80C186EC/80C188EC AND 80L186EC/80L188EC EMBEDDED MICROPROCESSORS SPECIFICATION UPDATE

Release Date: July, 1996

Order Number 272898-001

Figure 1. NMI Ignored During HLT Entering Powerdown

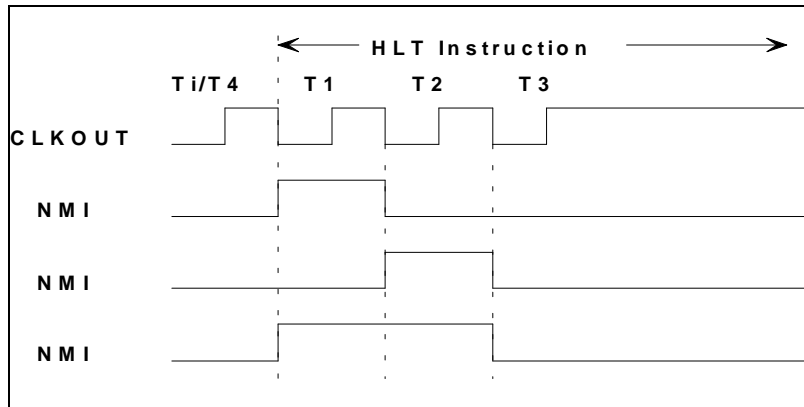
The problem occurs when an NMI occurs during execution of the HLT instruction. NMI is only serviced at valid instruction boundaries. The HLT instruction, when entering Powerdown, does not really have a boundary, it extends until Powerdown is exited. If NMI occurs between the beginning the T1 bus state and the end of the T2 state, but does not extend into T3, it will not be recognized, and the processor will enter Powerdown mode. The processor does not recognize the NMI request during the HLT instruction until the internal clock has stopped (at the end of T2).

The figures below show NMI occurring at different times during execution of the HLT instruction. Two cases are shown. Figure 1 shows cases where NMI is not recognized. Figure 2 shows cases where NMI is recognized. Both cases assume setup and hold time requirements are met for the NMI input.

In a typical system design using Powerdown mode, NMI can only occur after Powerdown is entered and the clock is stopped. The simplest solution to the problem is to not assert NMI unless the processor has entered Powerdown Mode.

If the system requires periodic NMI pulses, then the NMI pulse width must be long enough to ensure that it will extend into the T3 state of the HLT instruction. A NMI pulse width of three CLKOUT periods guarantees this.

Figure 2. NMI Recognized During HLT Entering Powerdown

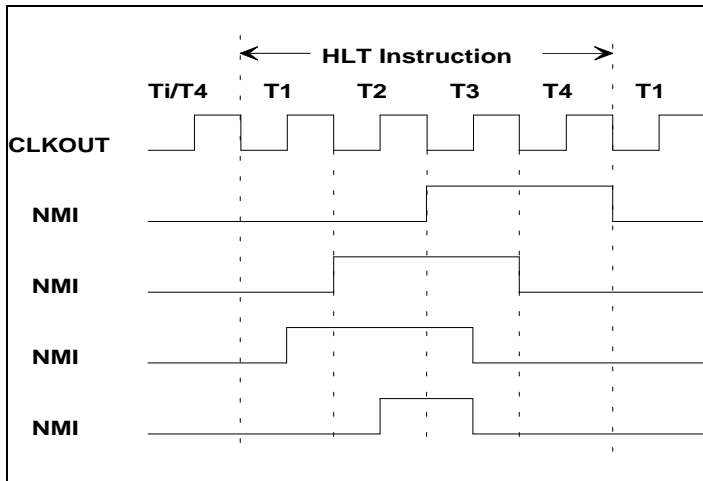
For the NMI to be recognized during the execution of the HLT instruction, the pulse must extend into T3. At this point, the processor has entered Powerdown and synchronized the NMI pulse. The NMI will be processed, but the processor will never enter Powerdown. Essentially, because NMI is active, the processor exits Powerdown as soon as it enters.
